Title: **DSP-30 Strain Relief Removal**
Bulletin #: DSP0005 Issue Date: May 30, 2003
Models Affected: DSP-30 Bulletin Revision: A
Production Range: 09/2001-5/2003 (serial# 0901xxxxx-0503xxxxx)

Figure 1. The RS232 ribbon cable that connects to J4 on the main PCB.

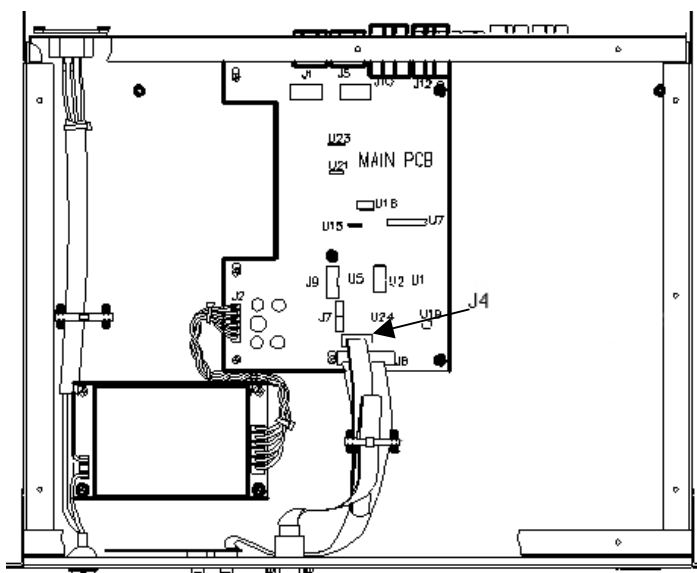
The RS232 ribbon cable that connects to the main DSP board does not latch properly.

The strain relief inhibits the cable from locking, which will result in no communication through the RS232.

1. Disconnect the DSP from AC and wait at least 10 minutes for internal voltages to bleed down.
2. Remove the top cover.
3. Locate the RS232 cable that connects to J4 and remove. Refer to *figure 1*.
4. Use small diagonal cutters to cut one end of the strain relief. Refer to *figure 2*.
5. Remove the remaining strain relief.
6. Reconnect the header into J4 and make sure it locks. Refer to *figure 3*.
7. Re-install the top cover and return the unit to service.
